Re: Red Cliffs Coalition Issues with the Inclusion and Consideration of Cost Estimates in the Northern Corridor Final Environmental Impact Statement, 2800 (UTC0300), UTU-93620

**Attachment to letter dated October 23, 2020, Red Cliffs Coalition Issues  
with the Inclusion and Consideration of Cost Estimates in the Northern Corridor Final  
Environmental Impact Statement (2800 (UTC0300), UTU-93620):  
Alternative 5 Variations to be Considered in Cost Estimates**

**Figure 2: Properties impacted by access limited by the 1000E-RHPW grade-separated intersection, per DEIS**

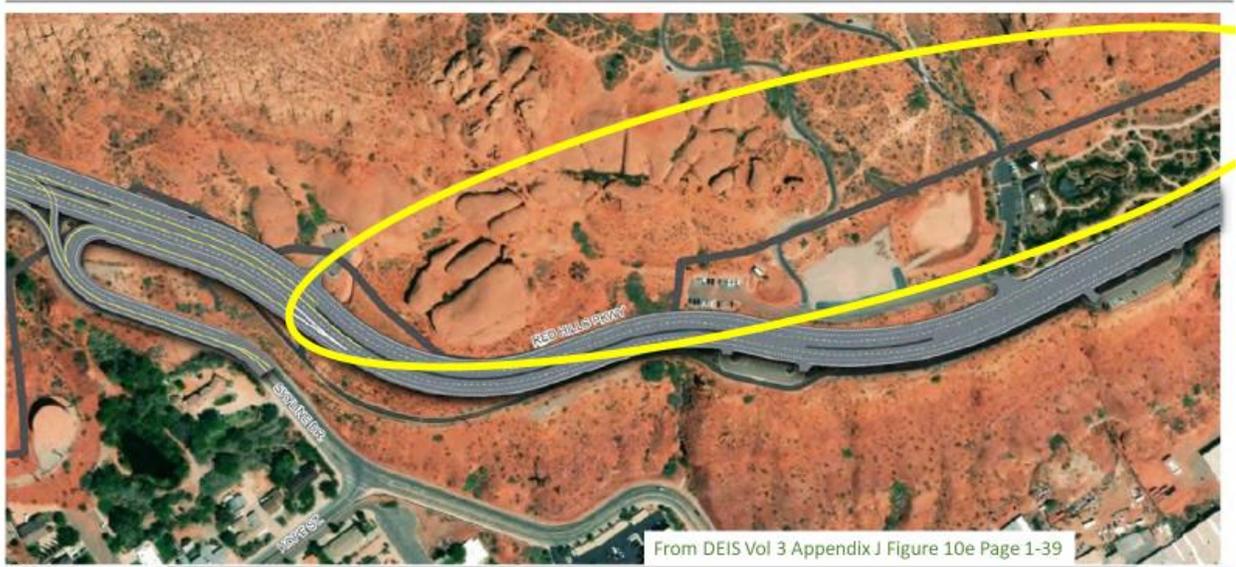
1. RHPW is elevated from west of 900E to west of Highland Dr. (see figure 1 item A).
2. 1000E has an efficient grade-separated connection with RHPW (see figure 1 item B).
3. 1000E also has the ability to connect directly to and from I-15 via the flyover (see figure 1 item C).
4. 200E has a grade-separated connection with RHPW.
5. Businesses/traffic in the area north and south of RHPW between Water Works Dr and 350N are impacted due to the limited or eliminated access from Water Works Dr, 900E, Industrial, and Highland (see figures 2, 3, and 4).

4. DEIS Alternative 5 requires street closures and access limitations, and identifies businesses impacted by them without apparent rationale. For example:
  - There is no apparent consideration given to connecting 350N with Water Works Dr. to enable businesses and other roads in the vicinity to access 1000E and then onto RHPW (see Figure 7).
  - There is no apparent reason presented for dead-ending Highland Dr just short of RHPW, since the flyover is elevated at this point, not blocking its connection to RHPW.

**Figure 5: CSU Alternative 1 Option 1**

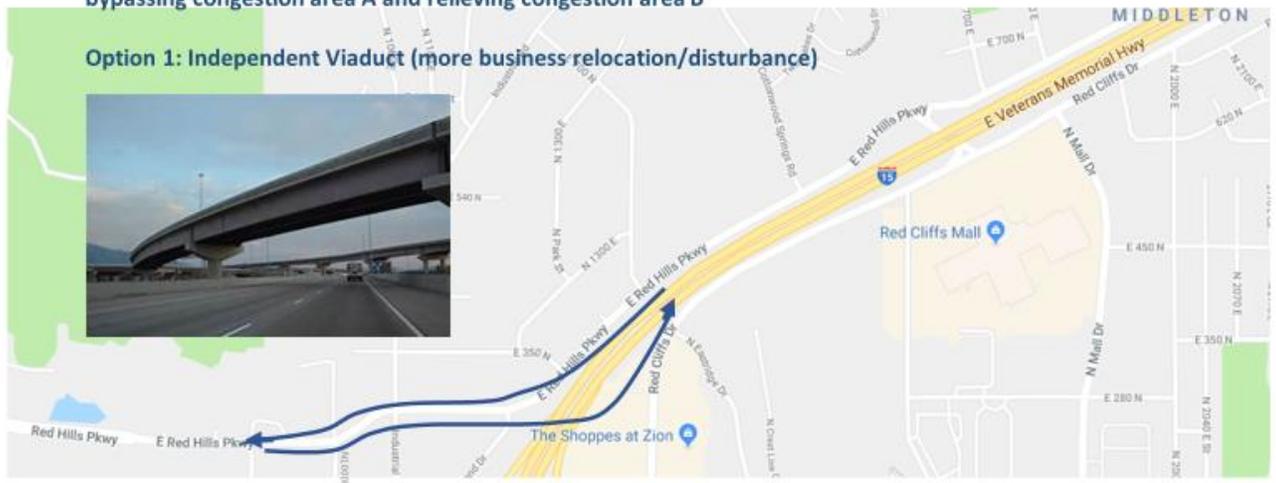
CSU Alternative 1 (see figures 5 and 6) does not change any existing RHPW intersections; it only adds the flyover connections with I-15, addressing only the stated DEIS purpose and need. It offers two options for the flyover location and design, both different than that defined by DEIS Alternative 5. The south-bound I-15 flyover to west-bound RHPW would join RHPW at optional locations, to be determined by modeling. Our intuition is that Option 1 is better, to reduce congestion at 900E and 1000E, however this could change if elements of CSU Alternative 2 are to be implemented at some point. Option 2 aligns fairly closely with DEIS Alternative 5's implementation of the flyover element only. Option 1 has more property impacts than option 2 because it "flies over" businesses rather than follow the existing RHPW footprint, but much less than DEIS Alternative 5.

1. The grade-separated intersection at 1000E is not required to satisfy the DEIS' purpose and need statement. The flyover connection of RHPW and I-15 can be implemented without it (see CSU Alternative 1, figures 5 and 6). While adding this complex intersection may help downtown St. George traffic, that issue is not within the scope of the DEIS. It would be a St George city consideration to integrate it with the flyover. Without it, most projected property impacts described in the DEIS<sup>10</sup> would be eliminated.

**Figure 6: CSU Alternative 1, Option 2**

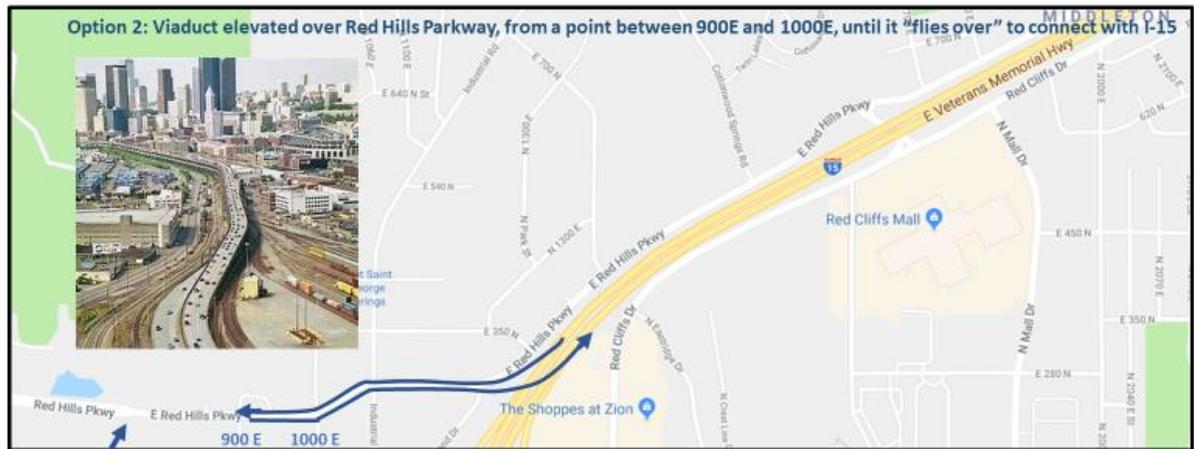
**Option 2A: Begin the viaduct farther west on Red Hills Parkway, causing no impact to existing 900E and 1000E intersections (this option is most directly comparable to DEIS Alternatives 2-4 in terms of addressing the Purpose and Need)**

**Figure 8: Access to RHPW from Pioneer Park, the Water District, City Utilities, Industrial Park**

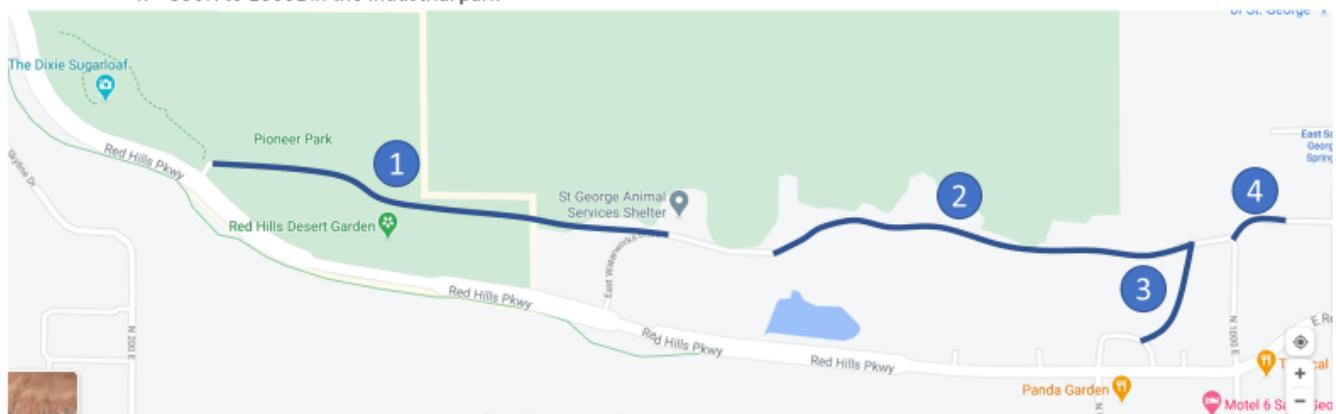
These omissions seem to unnecessarily burden businesses in the area. Accommodations could eliminate many of the property impacts (see Figure 8). Note that these issues have nothing to do with the DEIS alternatives analysis since they are not required to address the purpose and need statement, but rather are unrelated improvements to St. George traffic flow.

1. Pioneer Park/Desert Garden parking lot with Water Works Dr behind the Water District
2. Water Works Dr to 350N and 1000E behind the city utilities property
3. 900E to 350N next to city utilities
4. 350N to 1000E in the industrial park
